# Jan 2026 MDG Proposed Updates

Revision Type	Reference	Section Description (Red indicates Change of name from existing)	Description of Revision	New or Deletion	Primary POC
MDG	ALL Chapters	Many	Editorial update throughout MDG to change "Shared Use" to "Shared-Use" to be consistent with MUTCD		Alford / Fiant
MDG	ALL Chapters	Many	Revised uses of "shared lane" and replaced with "shared-lane" to be consistent with usage in MUTCD		Alford
MDG	1.4	Definitions	Updated definitions for consistency with MUTCD		Alford
MDG	2.3.1.1	Planning Resources	Updated Streetlight Data Row to indicate account access provided through Office of Planning rather than Office of Roadway Engineering. Also, removed safety data available timeframe years in Walk.Bike.Ohio row.		Alford
MDG	Table 3-2	Mean Walking Speeds for Disabled Pedestrians and Users of Various Assistive Devices	Corrected walking speed for Above-knee amputee row in table		Alford
MDG	Figure 3-3	Example of Mutual Yielding Zones Illustrating Intersection Sight Distance Case A	Update figure to show current MUTCD bike symbol marking		Alford

**Figure 6-37: Example Bike Lanes on Streets under 35 mph with Right Turn lanes < 200 Ft. in Length**

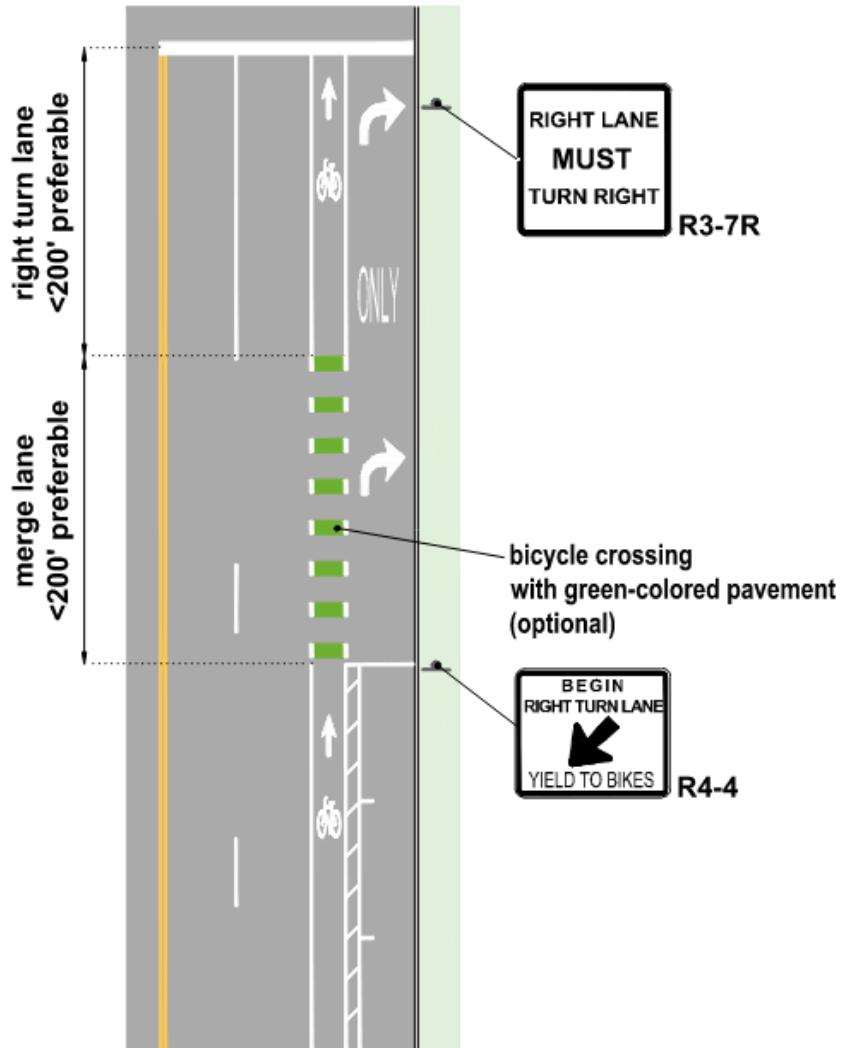
MDG	Figure 6-37	Example Bike Lanes on Streets under 35 mph with Right Turn lanes < 200 Ft. in Length	Update figure to show new Bike Symbol per MUTCD and remove reference to Interim Approval for Green Colored Pavement		Alford
MDG	Figure 6-38	Example Bike Lanes on Streets over 35 mph or Right Turn Lanes > 200 ft. in Length	Update figure to show new Bike Symbol per MUTCD (July updates provided tactile indicators and those are to remain). Also remove IA reference.		Alford
MDG	Figure 6-39	Through Lane Drops to Right Turn Lane with Bike Lane	Update figure to show new Bike Symbol per MUTCD and remove reference to Interim Approval for Green Colored Pavement		Alford
MDG	Figure 6-40	Example Right Turn Only Lane with Shared-Lane Markings	Update figure to show new Bike Symbol per MUTCD (July updates provided tactile indicators and those are to remain). Also remove IA reference.		Alford
MDG	Figure 6-41	Through Lane with Shared-Lane Markings when Bike Lane Ends before Intersection	Update figure to show new Bike Symbol per MUTCD		Alford

**Figure 6-42: Intersection Approach Options for Raised Bike Lanes**

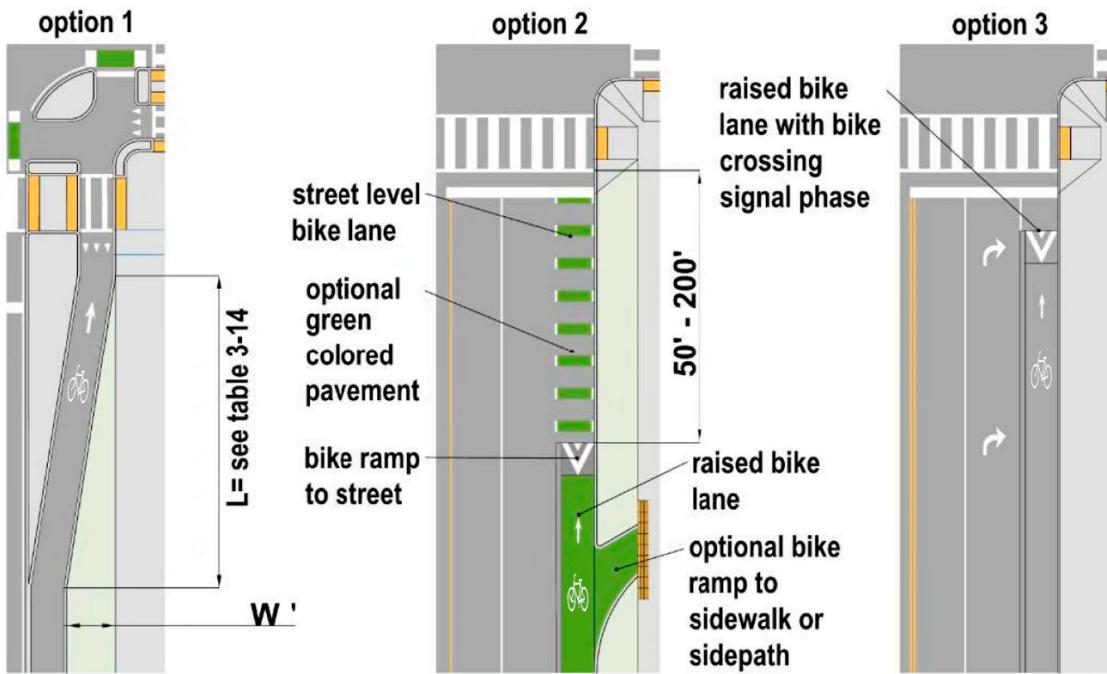
MDG	Figure 6-42	Intersection Approach Options for Raised Bike Lanes	Update figure to show new Bike Symbol per MUTCD (July updates provided tactile indicators and those are to remain).		Alford
MDG	6.5.5	Counter Flow Bike Lanes Intersection Design	Provided signcode for EXCEPT BICYCLES plaque and deleted sentence directing type of signal lens to use (since Bicycle Signal Head is now to be used).		Alford
MDG	Figure 6-43	Signing for Counter-flow Bike Lanes	Deleting Figure. Keeping Figure 6-43 Title as placeholder for future	Deletion	Alford
MDG	Figure 6-45	Example Paved Shoulder Markings to Accommodate Bicycling	Update figure to show new Bike Symbol per MUTCD		Alford
MDG	Figure 6-46	Motorist Bypass Lane with Bicycle Lane	Update figure to show new Bike Symbol per MUTCD and add bike crossing markings		Alford
MDG	Figure 7-1	Actual Corner Radius vs. Effective Turning Radius	Correct figure to show diagonal lines oriented correctly		Alford

Figure 7-2: Typical Truck Apron Layout at a Protected Intersection

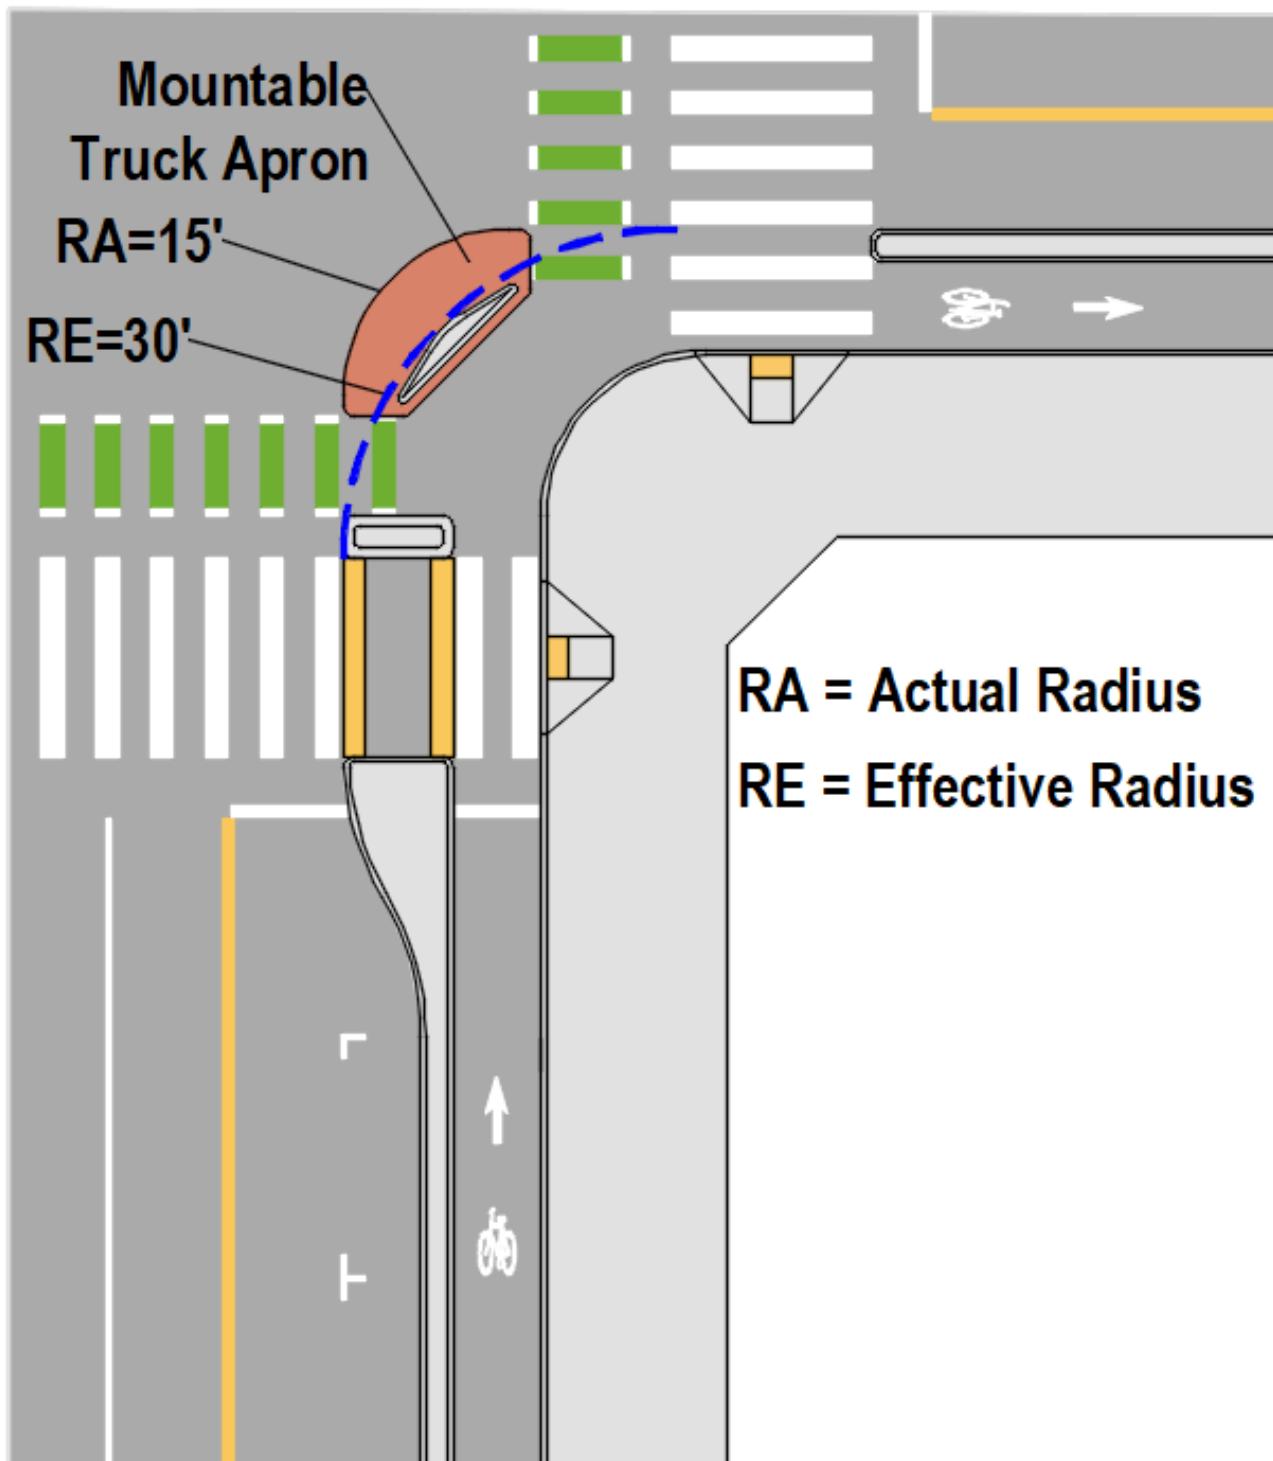
MDG	Figure 7-2	Typical Truck Apron Layout at a Protected Intersection	Update figure to show current MUTCD bike symbol marking		Alford
MDG	Figure 7-11	Schematic Examples of Mini-Roundabouts and Neighborhood Traffic Circle	Update Figure to show YIELD control on the left graphic rather than STOP control		Alford
MDG	7.8.3	Vertical Deflection	Update OMUTCD References		Alford
MDG	7.8.4	Street Width Reduction	Under header "One-Lane Pinch-Points" update sign nomenclature in bullet list for Designers to consider		Alford

**Figure 8-3: Accessible Pedestrian Pushbutton Locations with Separated Bike Lane**

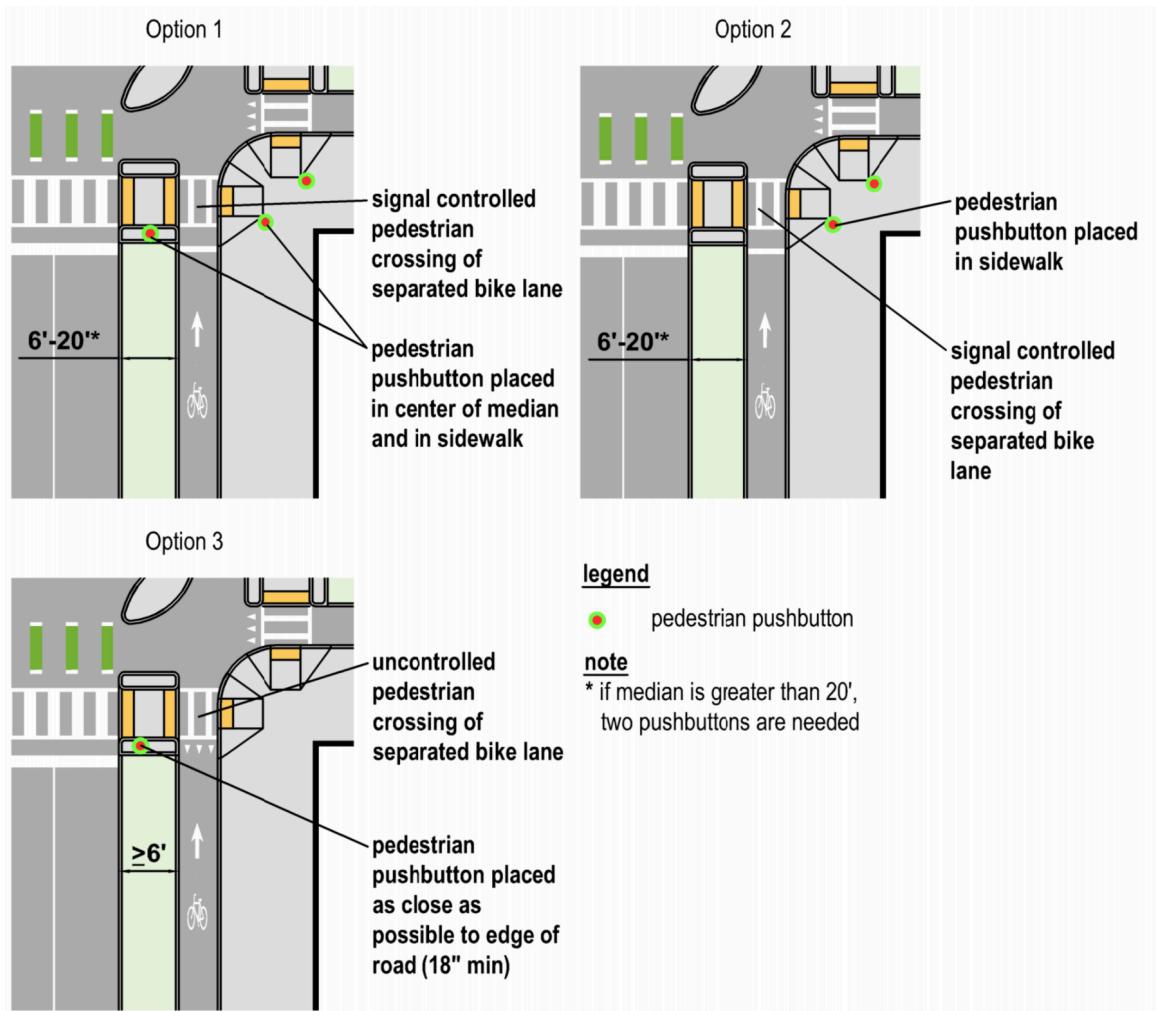
MDG	Figure 8-3	Accessible Pedestrian Pushbutton Locations with Separated Bike Lane	Update figure to show new Bike Symbol per MUTCD		Alford
MDG	8.4.4	Signal Timing and Reducing Bicycle Delay	Update OMUTCD references		Alford
MDG	8.4.5.1	Phasing Schemes	Removed reference to require use of standard traffic signal face or bicycle signal face when Bike movement is separate from vehical movement (now MUTCD requires bicycle signal face). Deleting the following statement, "Any of the signal indication options from Section 8.4.1 may be used to control bicyclist movements for an LPI except for the bicycle signal face." Also updated OMUTCD references		Alford
MDG	8.5	Toucan Crossings with Traffic Signals	Removed reference to Figure 8-6		Fiant
MDG	8.6	Pedestrian Hybrid Beacons	Update OMUTCD references		Alford
MDG	8.6.1	General Design Considerations	Update OMUTCD references and corrected sign callout		Alford

**Figure 9-2: Bike and Pedestrian accommodations at free-flow exit ramps**

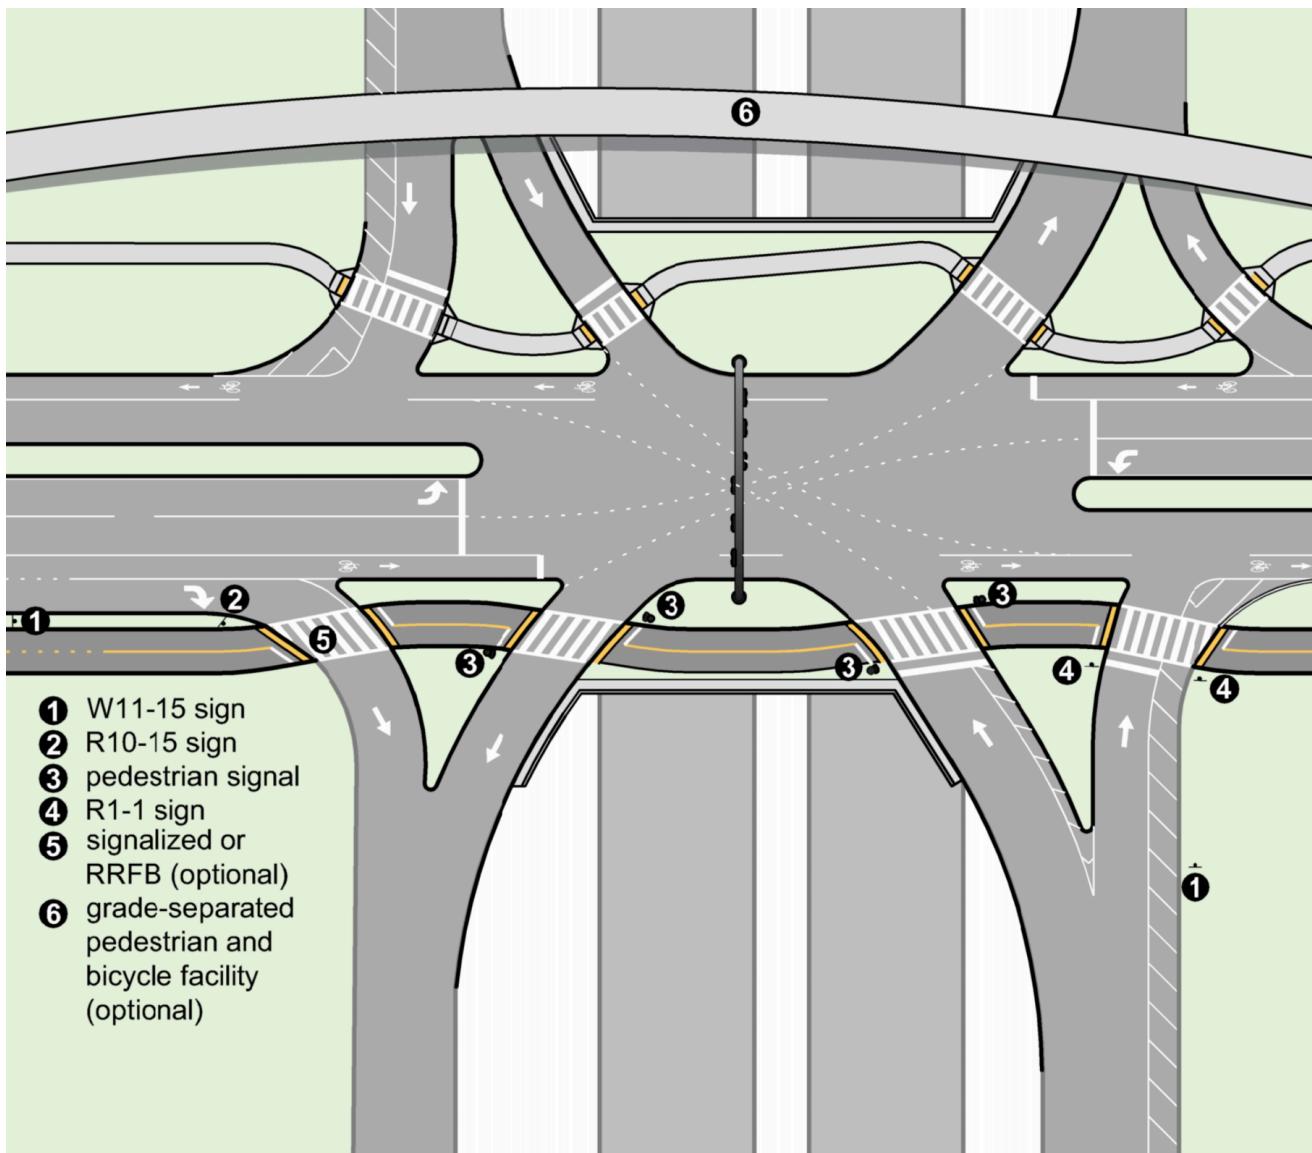
MDG	Figure 9-2	Bike and Pedestrian accommodations at free-flow exit ramps	Update figure to show new Bike Symbol per MUTCD		Alford
MDG	Figure 9-5	Various Bicycle and Pedestrian Treatments at a SPU	Update figure to show new Bike Symbol per MUTCD		Alford
MDG	9.4.4	Roundabout Intersections	Update language related to PHB's, Bicycle Considerations and also updated OMUTCD references		Alford
MDG	Figure 9-20	Bicycle Lane Transitions and Striping at a Multilane Roundabout	Update figure to show new Bike Symbol per MUTCD		Alford
MDG	Figure 9-21	Bike Lane Transition to Separated Bike Lane at a Roundabout	Update figure to show new Bike Symbol per MUTCD		Alford
MDG	10.3.3	Accommodating Transit Users - Bus Boarding and Alighting Area Accessibility	Revise to indicate boarding and alighting area max grade is less than 2.1% rather than 2.0% max.		Alford
MDG	Figure 10-1	Passenger Boarding and Alighting Area and Accessible Connections	Revise Figure to indicate 8.0 ft min starts at back of curb rather than face of curb		Alford

DWG 10-1.1

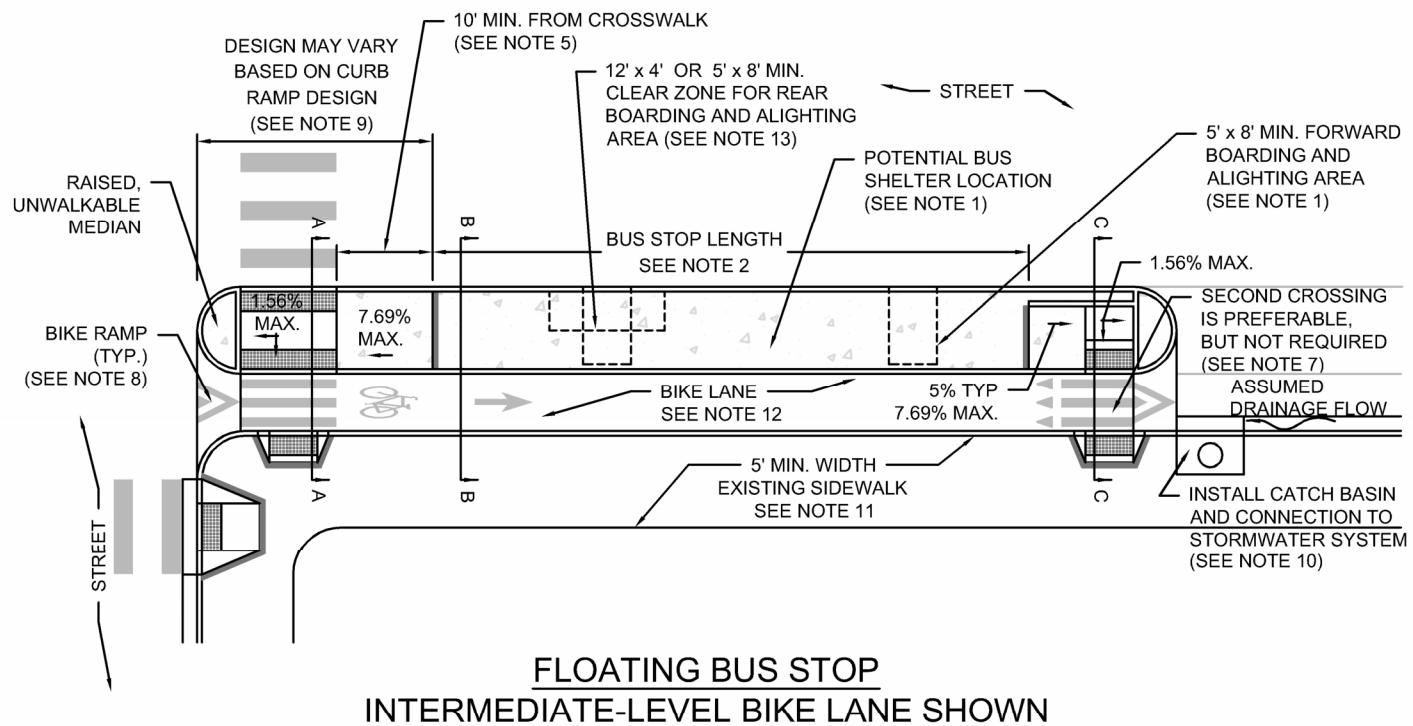
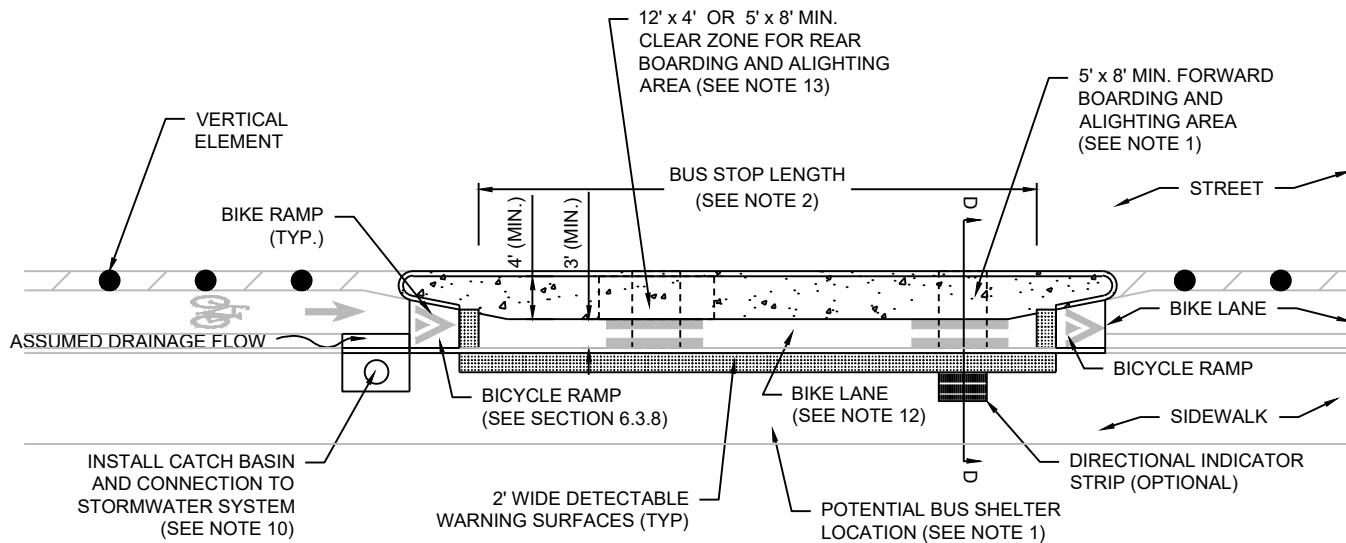
MDG	DWG 10-1.1	FLOATING BUS STOP DETAILS	Bike symbol needs to be updated per MUTCD. The speed hump marking on the right side of the platform is pointed the wrong direction and should be pointed the same direction as the marking on the left side.		Alford
MDG	DWG 10-1.3	FLOATING BUS STOP DETAILS	Bike symbol needs to be updated per MUTCD. The speed hump marking on the right side of the platform is pointed the wrong direction and should be pointed the same direction as the marking on the left side.		Alford
MDG	Many	Many	Update Figure callouts with removal of some Figures within chapter		Alford
MDG	11	Rail Crossings	Update intro paragraph to refer to OMUTCD Chapter 8 for Rail Crossing info in MUTCD.		Alford
MDG	11.1	Provision of Access and Design for Pedestrians and Bicyclists	Delete the following, "Section 5.1.3 discusses the provision of pedestrian facilities based on context and" in first paragraph and updated other MUTCD references.		Alford

**Figure 11-7: Automatic Gate Arm with Gate Skirt**

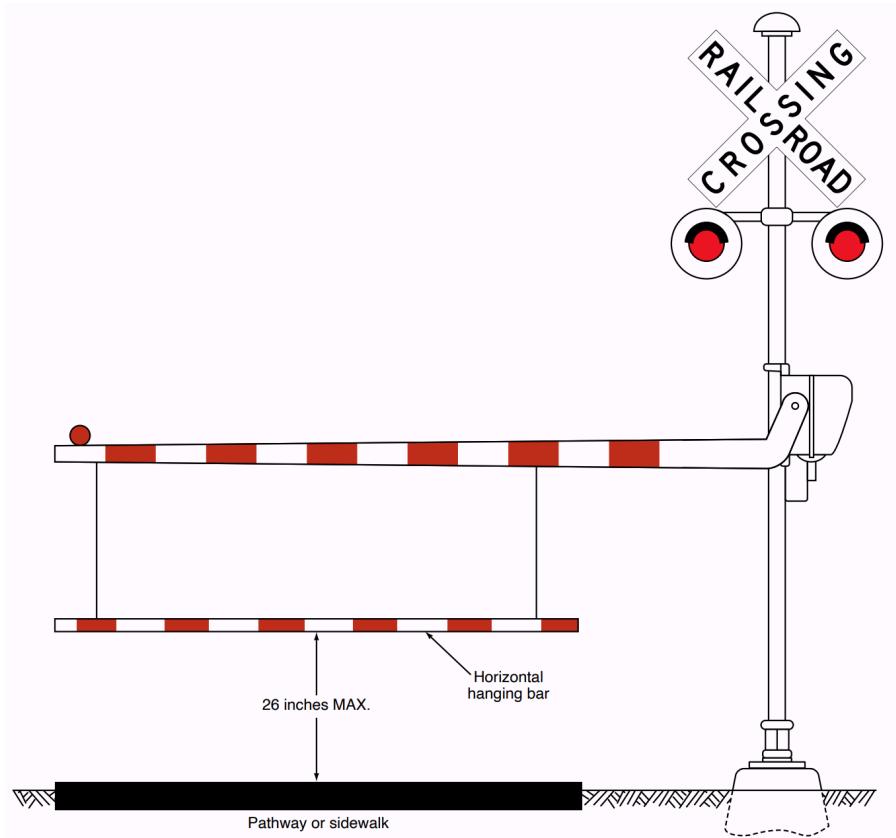
MDG	Figure 11-8	Automatic Gate Arm with Gate Skirt	Update Figure to be consistent with MUTCD 8E-12 and renumber to 11-7.		Alford
MDG	Figure 11-9	Automatic Gate for Pedestrian Facilities with an Emergency Swing Gate	Replace image with graphic and renumber to 11-8		Alford
MDG	11.5.4	Supplemental Treatments	Deleted "Pedestrian Swing Gates" section since not covered in 11th Edition of MUTCD	Deletion	Alford
MDG	Endnotes	Chapter 11 Endnotes	Deleted Endnotes	Deletion	Alford
